Geotechnical Investigation Proposed Residential Building

230-232 Lisgar Street
Ottawa, Ontario

Report PG6401-1 Revision 2 dated October 18, 2023

re: Geotechnical Response to City Comments
Proposed Residential Building
230-232 Lisgar Street - Ottawa
to: 230 Lisgar Street Inc. – **Mr. Albert Falsetto** – a.falsetto@rogers.com
to: Fotenn – **Ms. Jillian Simpson** – simpson@fotenn.com
date: October 18, 2023
file: PG6401-MEMO.01 Revision 2

Figure 1 - Approximate Locations of Frost Protection of The Site Servicing and Insulation Recommendations

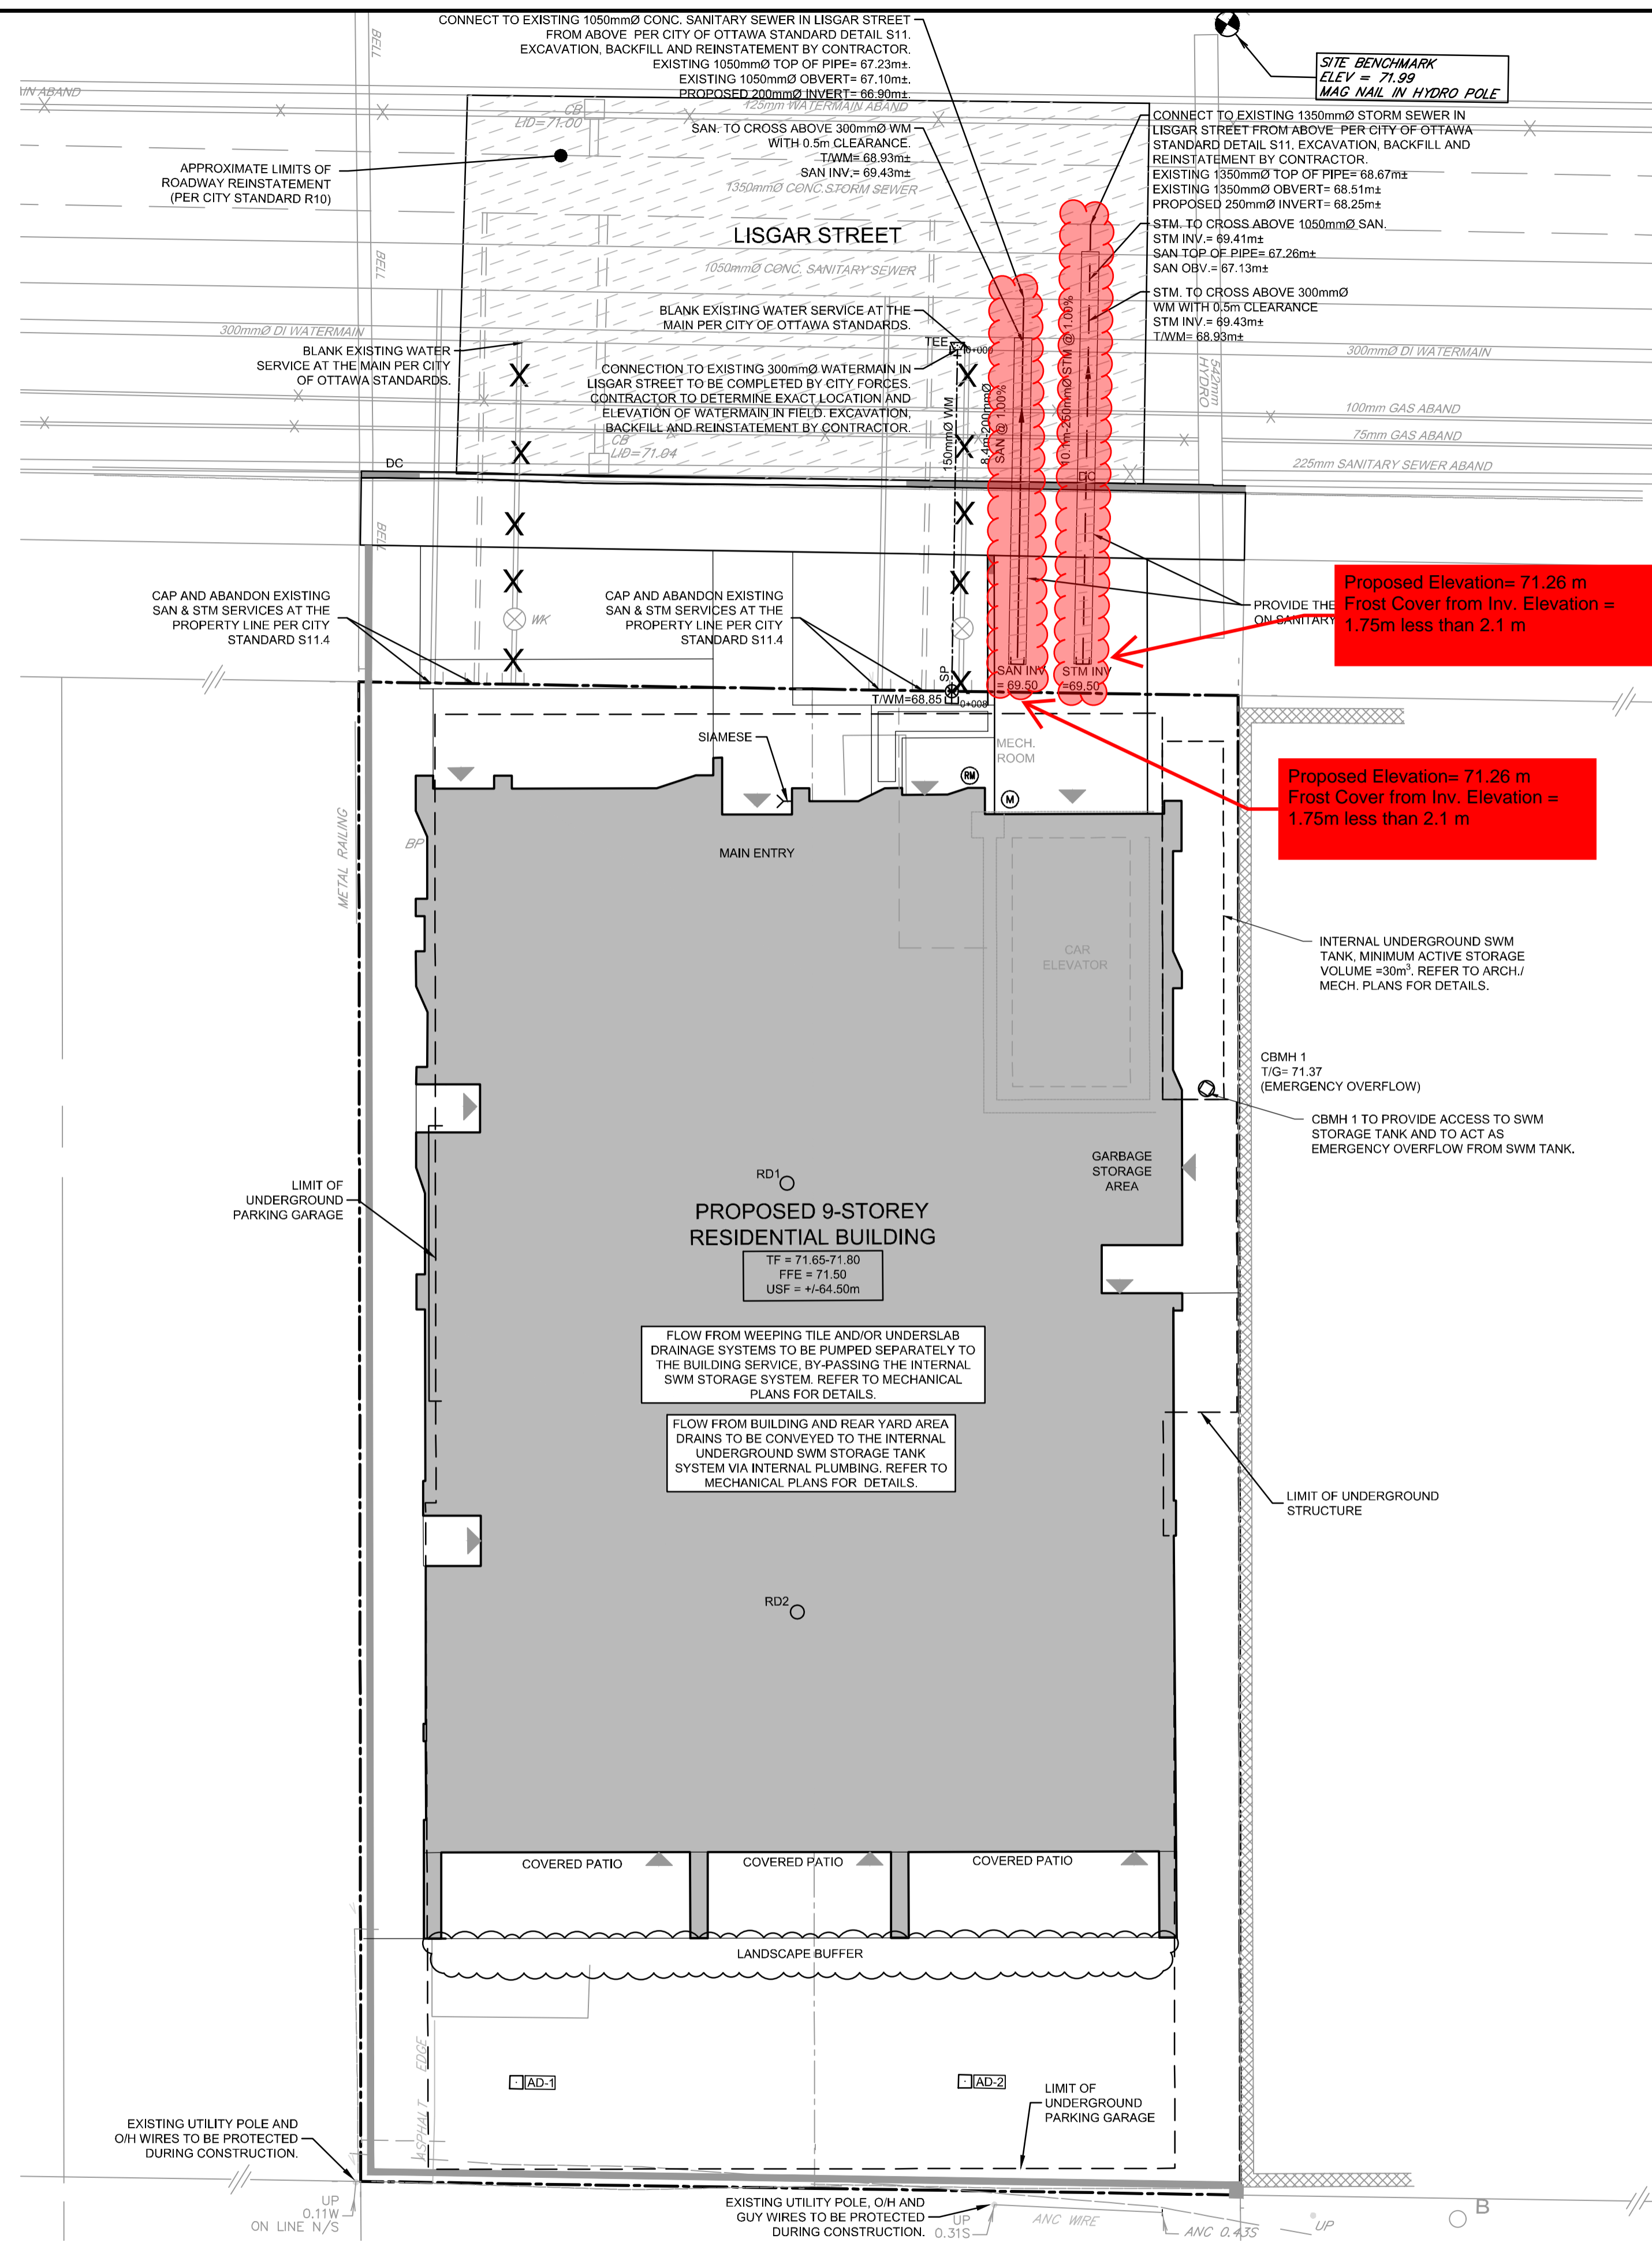
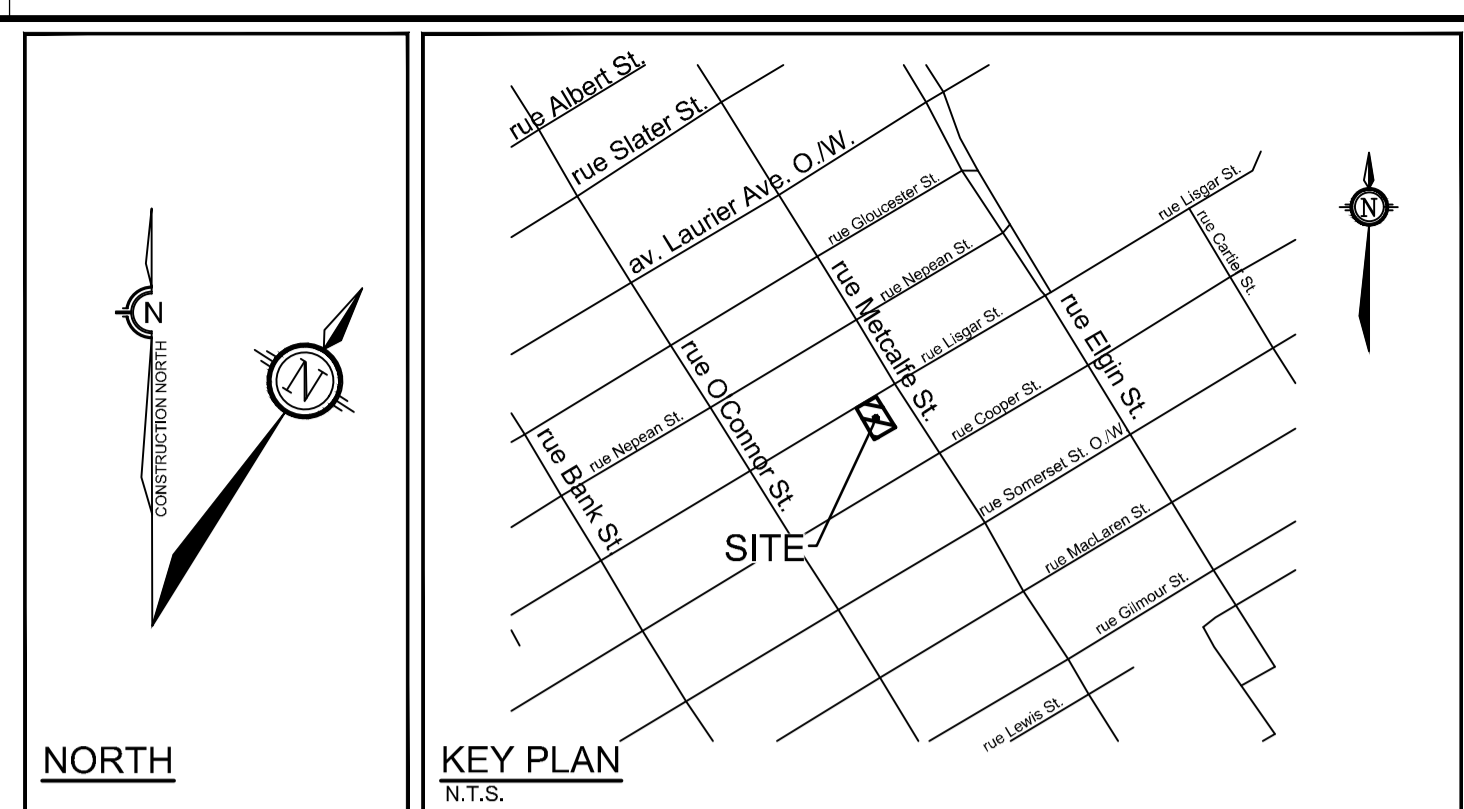
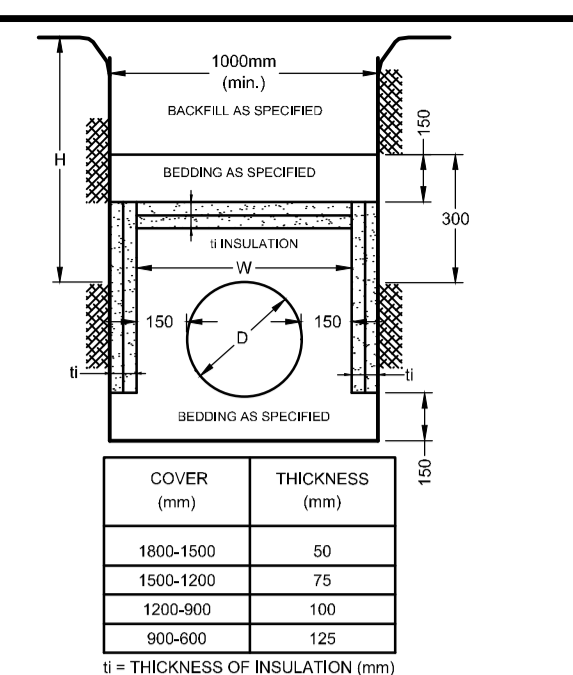
Based on our review of the above noted site service plans, The services were found to be outside of the lateral support zone of the proposed footing and be considered to be acceptable from a geotechnical perspective. However, insufficient frost protection has been provided for the storm and sanitary sewer services. At these locations, the storm sewer services are located within the frost zone, approximately 2.1 m below the finished grade.

Refer to Figure 1, attached to the current memorandum, which demonstrates these approximate locations. In the following section, frost protection of the site servicing is recommended where insufficient frost cover has been provided.
